IN THE MATTER OF AN APPLICATION TO
AN BORD PLEANÁLA

FOR APPROVAL OF (I) THE N6 GALWAY CITY RING ROAD
PURSUANT TO SECTION 51 OF THE ROADS ACT 1993 (AS
AMENDED); (II) THE N6 GALWAY CITY RING ROAD
MOTORWAY SCHEME 2018; and (III) THE N6 GALWAY CITY
RING ROAD PROTECTED ROAD SCHEME 2018

ABP Ref. ABP-302848-18 and ABP-302885-18

STATEMENT OF Evidence
Responses to Hydrogeology
Objection/Submissions

Figure 1: Location of property in submission/objection Ob_152

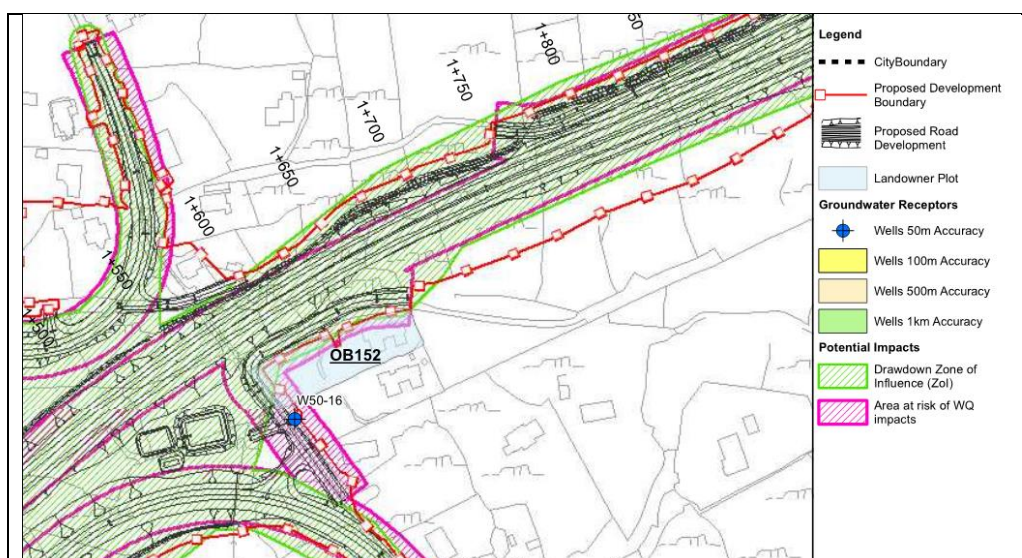
- Ob_152: The submission notes the presence of a ‘natural spring well’ on their grounds and questions whether it will be impacted during construction. It notes that this spring is not identified as a constraint in the EIAR.

- 4.3.10 Submission/objection Ob_152 raises an issue in relation to spring/well (W50-16). Spring/well W50-16 is located in granite, located adjacent to earthworks EW02, which comprises of embankment with a short section of shallow cutting (Ref Figure 10.6.002 of the EIAR). The spring/well lies within the footprint of a side road and will not be retained. As part of the proposed road development the well will need to be decommissioned. Where wells are removed as part of the proposed road development then an alternative equivalent supply will be provided such as a replacement well.

Figure 2: Location of property in submission/objection Ob_239

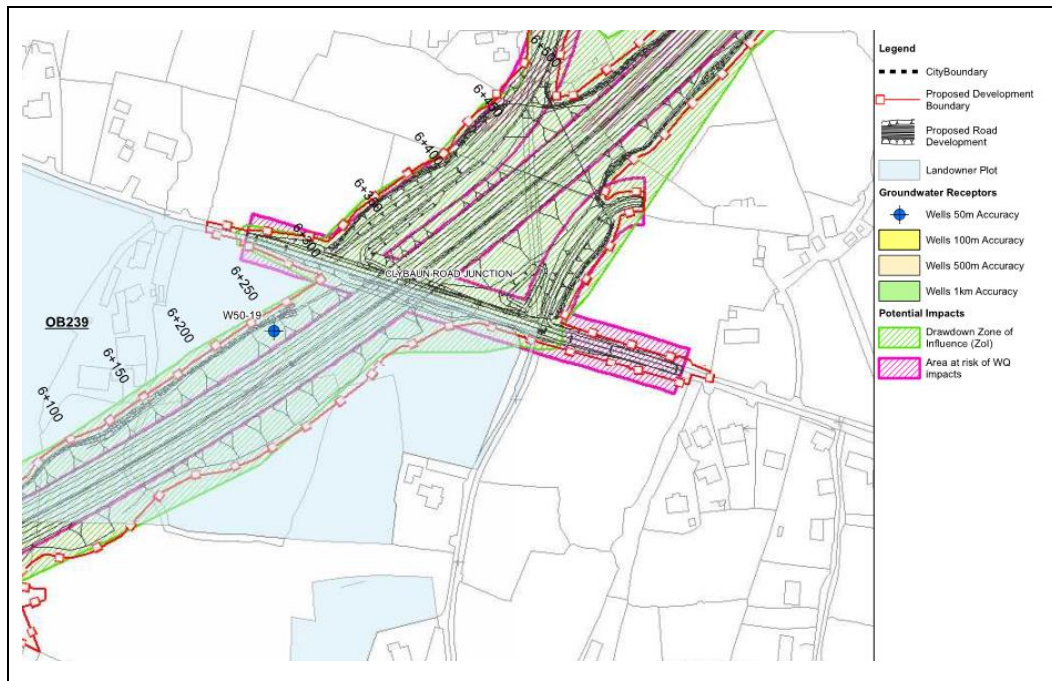
- Ob_239: The submission (point no. 4) notes concern regarding impact to well located close to the proposed road development.
 - Ob_311: The submission requests that their water source (private well on site) will not be interfered with.

4.3.11 Submission Ob_239 raises an issue in relation to a well (W50-19). Well W50-19 is located in granite, adjacent to earthworks EW08, which comprises of embankment (Ref Figure 10.6.005 of the EIAR). The well lies within the footprint of the embankment and will not be retained. As part of the proposed road development the well will need to be decommissioned. Where wells are removed as part of the proposed road development then an alternative equivalent supply will be provided, such as a replacement well.

Figure 4: Location of property in submission/objection Ob_496

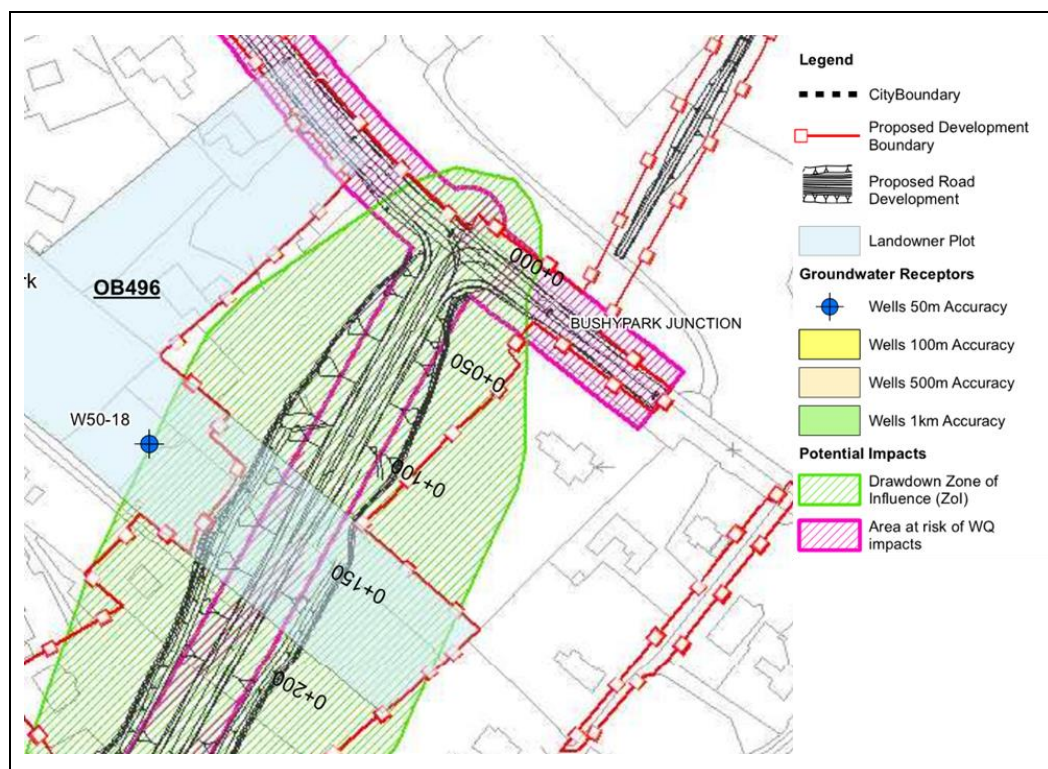
- Ob_496: The submission states that a road cutting included as part of the proposed road development will impact their well and queries whether the well will be monitored.

- 4.3.13 Submission Ob_496 raises an issue in relation to a well (W50-18). Well W50-18 is located in granite, adjacent to the N59 Link Road North. The well is the at the margins of the zones for drawdown impacts, both of which have been assessed on a conservative basis. As part of the proposed road development the well will need to be decommissioned. Where wells are removed as part of the proposed road development then an alternative equivalent supply will be provided, such as a replacement well.

Figure 8: Location of property in submission/objection Ob_134

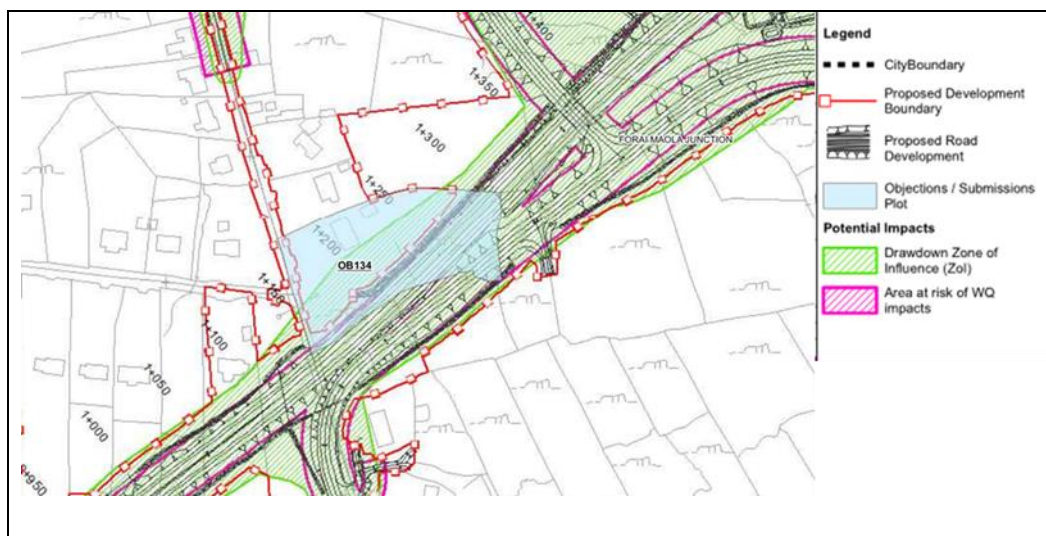
- 4.9.2 The submission raises the concern that the groundwater levels will drop beneath the property and cause instability. The way in which groundwater levels could fall due to construction and operation activities are outlined above in Section 4.2 above and assessed in detail in Table 10.17 in Section 10.4 of Chapter 10 of the EIAR. As outlined above, the location of the property relative to the zone of influence of any dewatering or large drainage run is the most important element to understand if there is likely to be a risk of groundwater levels falling.

- 4.9.3 The zone of dewatering is shown on the figure below relative to the property. It can be seen that this property is on the edge of the zone of influence of the drawdown (Figure 8). This means that in this area the groundwater levels may reduce but by a very small amount. For this reason a property condition survey will be undertaken in accordance with commitment C17.19 of Chapter 21 of the EIAR.

Job No: **233985-00** | Drawing No: **Figure 8.01** | Issue: **I2**

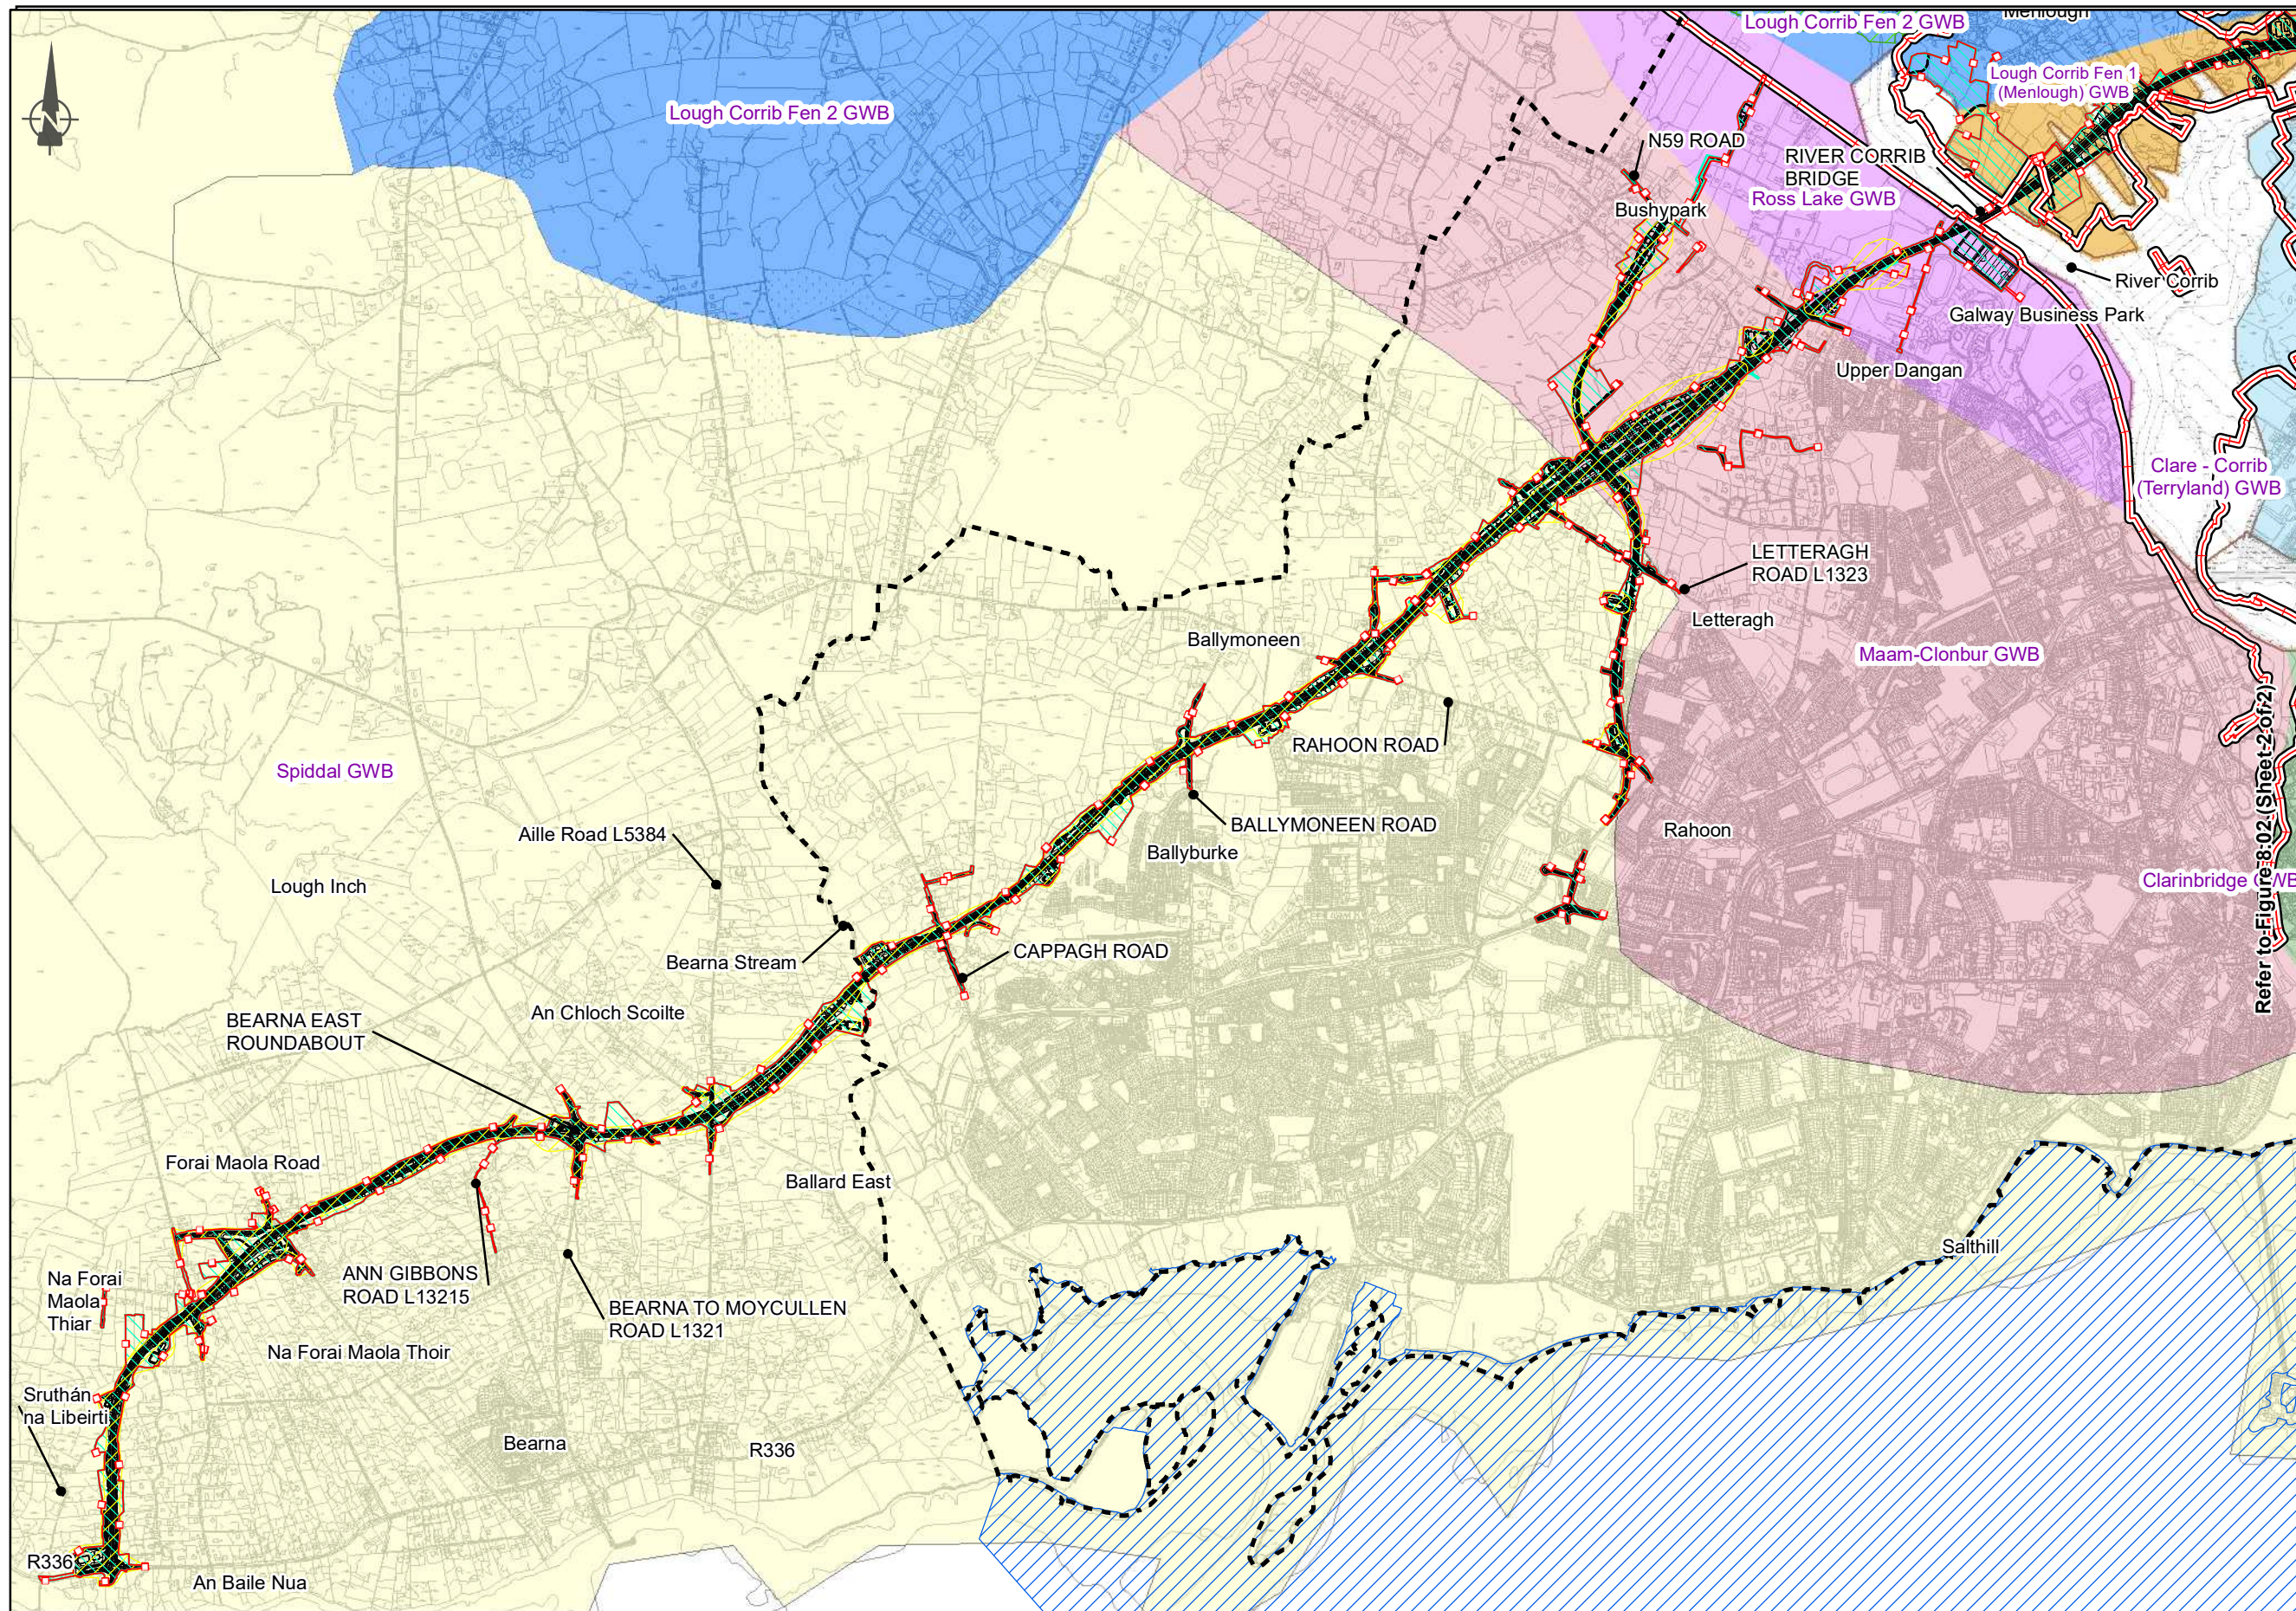
NIS Appendix A Figure 8.01 and Figure 8.02 are (i) missing a legend and (ii) had colouring errors relating to Spiddal and Maam-Clonbur.

NIS Appendix A Figure 8.01 has had the following added:

Job No: 233985-00 | Drawing No: Figure 9.01 | Issue: 12

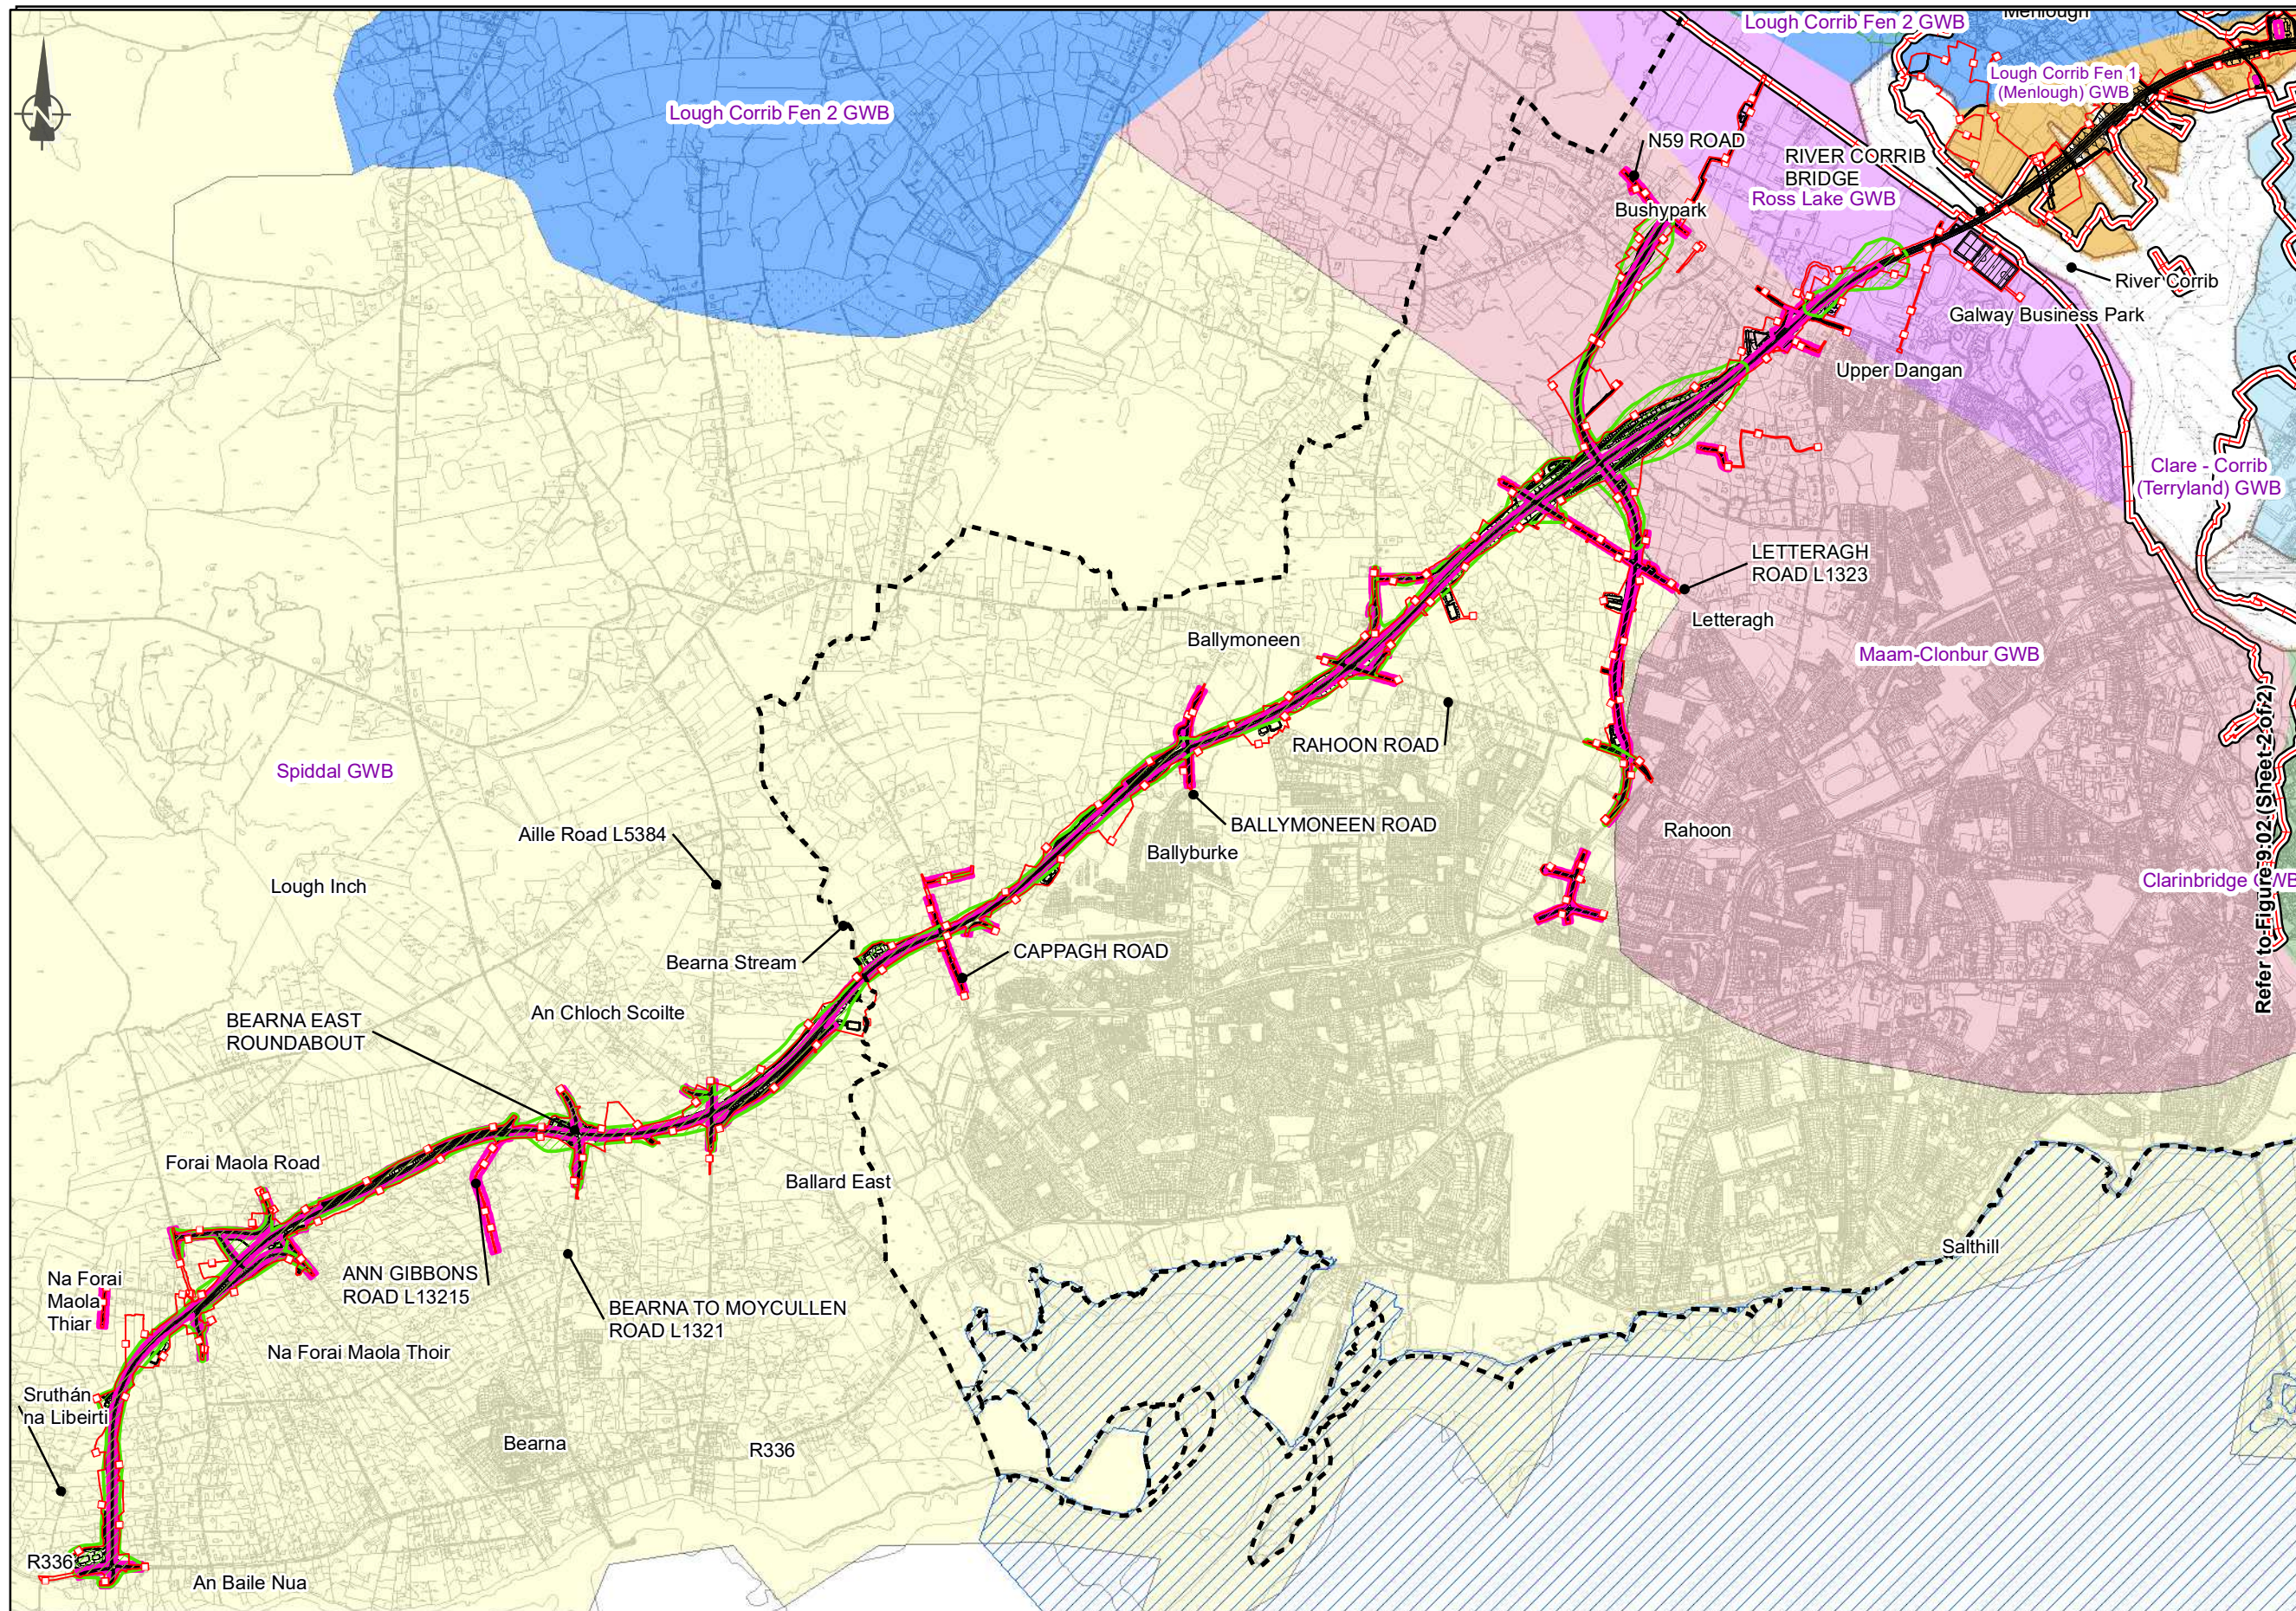
NIS Appendix A Figure 9.01 and Figure 9.02 are (1) missing a legend and (2) had colouring errors in regard to Spiddal and Maam-Clonbur.

NIS Appendix Figure 9.01 has had the following added:
